Project	IEEE 802.16 Broadband Wireless Access Working Group < http://ieee802.org/16 >	
Title	Obtaining Sleep Mode Information in RS	
Date Submitted	2006-11-17	
Source(s)	<p>Yuefeng Zhou; Mike Hart; Sunil Vadgama Fujitsu Laboratories of Europe Ltd Hayes Park Central, Hayes End Road, Hayes, Middlesex, UB4 8FE, UK</p> <p>Shiao-Li Tsao, Fang-Ching Ren, Wern-Ho Sheen, I-Kang Fu National Chiao Tung University (NCTU) /Industrial Technology Research Institute (ITRI), Taiwan No. 195, Sec. 4, Chung Hsing Rd., Chutung, Hsinchu, Taiwan 310, R.O.C.</p>	<p>Voice: +44 (0) 20 8573 4444 FAX: +44 (0) 20 8606 4539 yuefeng.zhou@uk.fujitsu.com mike.hart@uk.fujitsu.com sunil.vadgama@uk.fujitsu.com</p> <p>Voice: +886-3-5712121-54717 Fax: +886-3-5721490 E-mail: sltsao@cs.nctu.edu.tw; frank_ren@itri.org.tw</p>
Re:	IEEE 802.16j-06/027: "Call for Technical Proposals regarding IEEE Project P802.16j"	
Abstract	In MR networks, RS could have more flexibility for scheduling, if it can obtain sleep mode information.

Obtaining Sleep Mode Information in RS

Fig. 1. RS decodes the MOB_SLP_RSP message for further scheduling

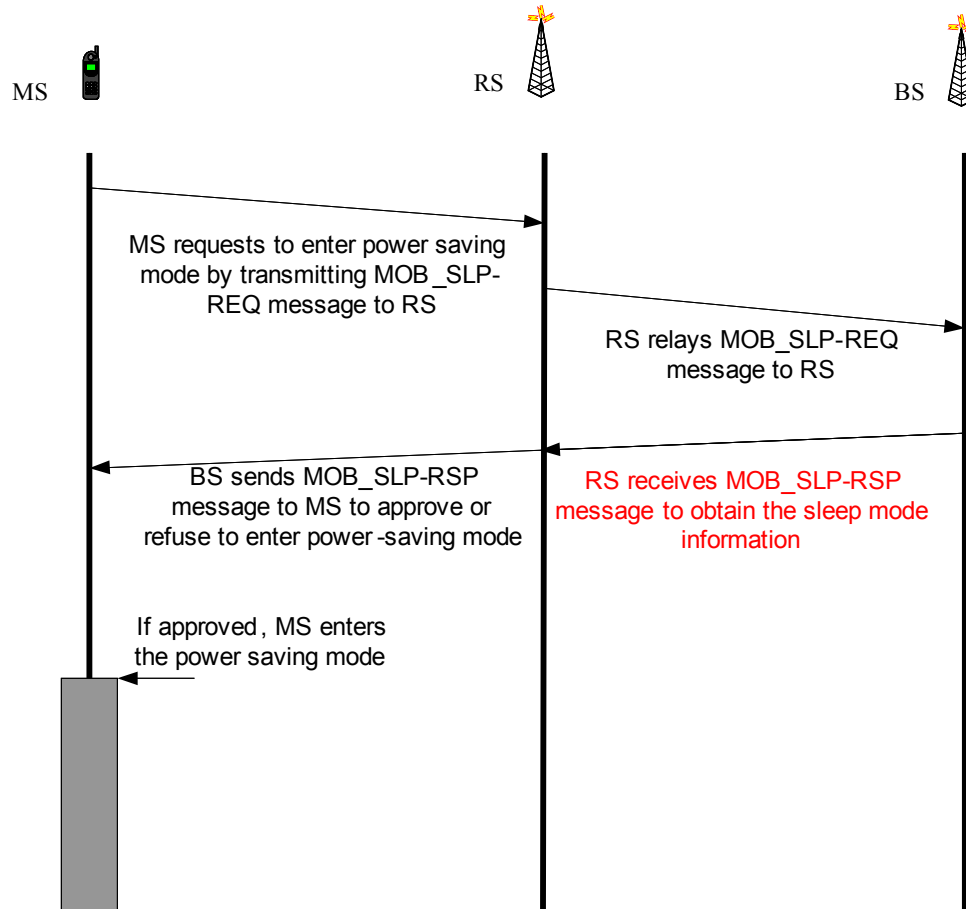
RS may have the capability to listen and decode the MOB_SLP_RSP message to obtain the sleep-mode information. For example, if the sleep mode is initialized by MS, as shown in Fig. 1, RS shall decode the MOB_SLP_RSP message sent by MR-BS to obtain enough timing information, thus it can allocate resources to MS on time for the event-based actions, also RS can avoid sending management messages to this MS, and can cancel the bandwidth allocated to MS during the sleep period.
